**Terex Utilities****PRODUCT NOTICE****PN689****DATE:** 4/14/2021**REVISED:****TO:** Owners, Users, Dealers, and Installers**MODELS AFFECTED:** TL80, TL80/112, & TL100**SUBJECT:** Leveling System**Issue:**

**Figure 1. Bleed kit with bleed valve at upper controls**

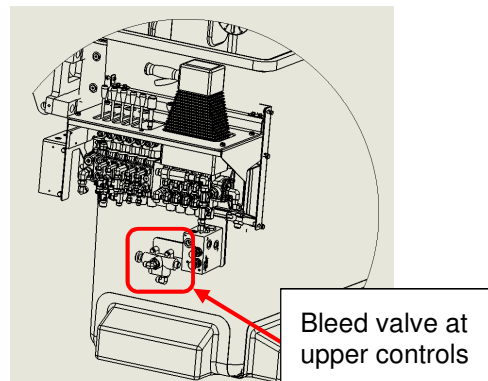
1. Immediately inform all users, operators, and supervisors that the leveling system must be inspected daily before use.
2. Inspect the unit's leveling system to determine if it has the following conditions using the figures as reference. The conditions below apply to all Transmission TL models (TL80, TL80/112, and TL100).
  - Addition of a leveling system bleed kit – Field Service Kit Z1584  
Leveling bleed kit may have been added to allow any trapped air to be bled from the leveling circuit. Trapped air could result in delayed leveling response. If either method shown below was installed, the bleed kit is not needed.

- Z1584 – Bleed kit for leveling system
- Z1607 – Replacement elbow leveling cylinder
- Z1608 – Replacement boom-tip leveling cylinder
- Z1609 – Boom-tip leveling cylinder pin boss weld (no parts required)
- Z1611 – Add relief valve to rod end of elbow leveling cylinder circuit

**Figure 5. Boom-tip leveling cylinder location**

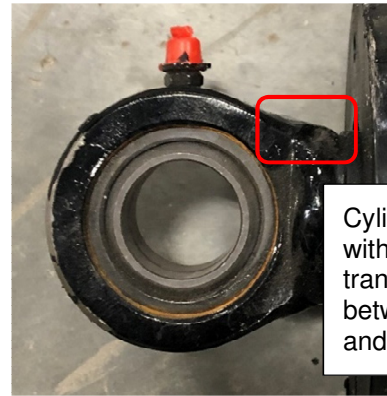
- Replacement elbow leveling cylinder (Field Service Kit Z1607) and boom-tip leveling cylinder (Field Service Kit Z1608)  
 Inspect elbow and boom-tip leveling cylinders to identify the leveling cylinder using the figures below. If both cylinders have the smooth weld transition from the rod eye to the rod, the cylinders do not need to be replaced.

Cylinder rod eye with smooth weld transition between rod eye and rod is correct.

**Figure 7. If the boom-tip leveling cylinder support bosses are not welded on the inside as shown, this bulletin applies**

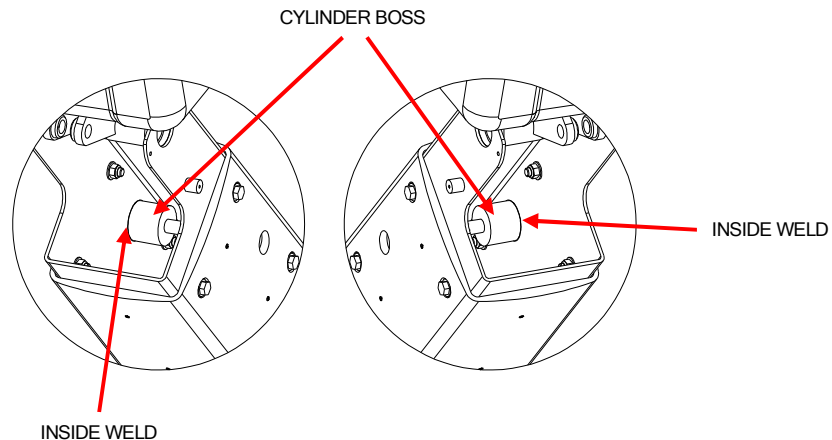
- Boom-tip leveling cylinder support boss inside weld – Field Service Kit Z1609  
 Some boom-tip leveling cylinder support bosses may not have been welded on the inside of the boom.

**Figure 8. If the valve shown is present, this bulletin may not apply**

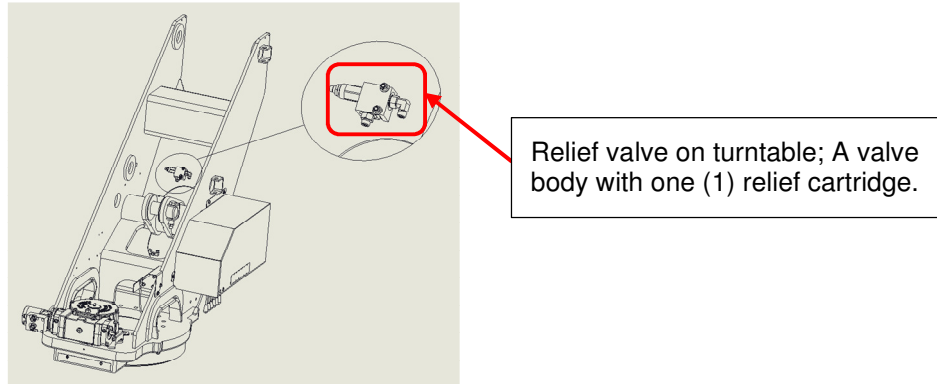
- Addition of a relief for the isolation valve – Field Service Kit Z1611  
The isolation relief valve for the leveling circuit is being added to protect the elbow leveling cylinder from damage in case the operator functions boom controls while also using the manual leveling control.
